SUBJECT: White Mesa Uranium Mill Cell 4A
Overflow Spillway from Cell 3 to 4A
Design Modification Approval

SPILLWAY SPLASH PAD ANCHOR DENISON MINES CELL 4A BLANDING, UT	
Geosyntec consultants	DATE: AUGUST 2008
	PROJECT NO. SC0349
FIGURE 1

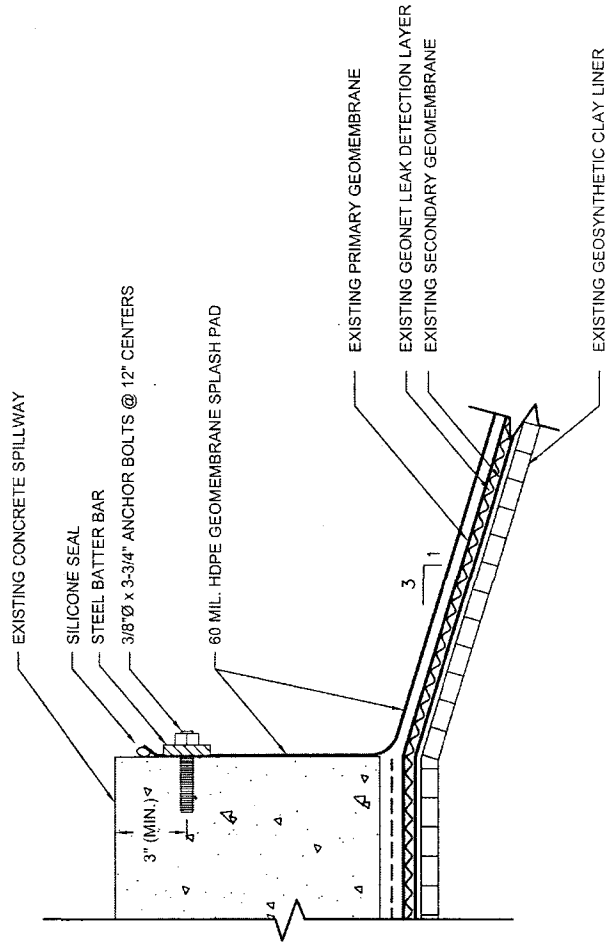
We have reviewed this information, and **hereby approve** the engineering design modification as received by email August 15, 2008, and described in the attached drawing by GeoSyntec titled *Spillway Splash Pad Anchor*, dated August 2008, project no. SC0349. The approved drawing includes four separate listed notes that also help describe the work. This modification adds a 64-foot wide 60-mil HDPE geomembrane splash pad to the downstream side of the new spillway. This width is to accommodate a potential PMF flood stage of 2.75 feet, which corresponds to the 64-foot width.

The HDPE splash pad is to be extrusion welded to the upper geomembrane liner of the cell on three sides, but as shown on the drawing, fastened at the top to the concrete spillway with a continuous or spliced steel batten bar, with anchor bolts at 12-inches on center. It is understood the HDPE splash pad sheets are to be welded together.

As documented in previous correspondence, the discharge edge of the spillway was completed approximately 1-foot above the DRC approved discharge elevation, as a result of deletion of a beveled taper of the concrete spillway to the upper geomembrane surface. Therefore, a splash pad addition was deemed necessary to protect the upper HDPE geomembrane adjacent the spillway from forces related to possible flood flow, and the mentioned drop in elevation.
